B-03 C14-2020-0151 - 8401 - 8407 South 1st Street; District 2

Commissioner Smith:

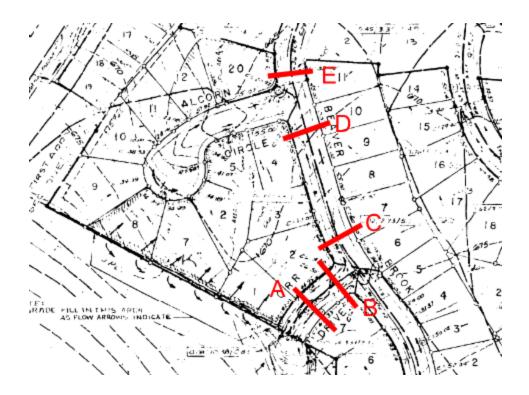
1. I understand the homeowners in the vicinity of Orr Drive and Beaver Brook Lane currently experience flooding in connection with 2-year storm events.

The applicant has proposed the following drainage improvements in connection with the proposed multifamily project.

- a. Regrade. Regrade the site along the north and east property lines and construct a retaining wall system at the perimeter to prevent water from sheet-flowing onto neighboring properties. The retaining wall system consists of a rock wall approximately 3' in height, with a 6' solid wood fence on top (total of 9' high).
- b. Reroute. Provide a drainage easement along south and east property lines to redirect and slow sheet flows that are otherwise traveling unabated across the subject property.
- c. Improve Orr Drive inlet. Rework existing inlet at Orr Drive and provide a level-spreader that will limit stormwater within the right-of-way, thereby preventing it from surging onto neighboring homeowners properties during a 100-year flood event.

d. Overdetain. Construct a subterranean detention pond onsite that is oversized more than required by City Code to capture on-site flows, in addition to reducing current off-site peak flow rates by 10%.

Please comment as to whether the above drainage improvements address existing drainage issues and will improve the existing drainage condition experienced by neighbors located adjacent to the Property along Orr Drive and Beaver Brook Lane.

The attached drainage area map shows the drainage for the proposed site at 8401 S 1st. Currently the site drains directly into the residential houses to the north. The proposed development, which you can see highlighted on the second sheet, is currently proposing to capture all flows and release them into the right of way on Orr Drive. This will completely take drainage off of the residential lots that drains directly onto their properties. They also propose to decrease the total flow that drains through their site. However, the site proposes to increase flow at Orr Drive which would require a waiver. As part of the drainage criteria manual requirements, there should be no increase in point discharge from any point of the development. The engineer has met with a few different members of staff to discuss possible solutions and over-detaining did seem to be the most feasible option as the City doesn't have proposed upgrades in this area.

It is difficult to have a general statement to state flooding conditions will be better because flows are diverted from one location to another. As part of the waiver request, we are asking for calculations to demonstrate the flows will be contained in ROW. There is preliminary information that they have provided that demonstrates flows to be contained in the right of way. In both existing and proposed conditions there is almost a foot of water in their calculations so flooding isn't completely mitigated. The increase of flow will be from Orr Drive to just past the intersection of Beaver Brook. Just as a visual, below is an exhibit that shows the points of calculation. An increase in flow is shown for cross sections A,B and C with flows decreasing at D and E and further downstream due to their proposed overdetaining. Flows in the screenshot below are moving up the page toward cross section E. As a side note, waivers are not typically handled at the zoning stage as we review these during site plans and construction plans when construction occurs. I believe the applicants are trying to address drainage now since it is a concern to the neighborhood for this particular hearing item.
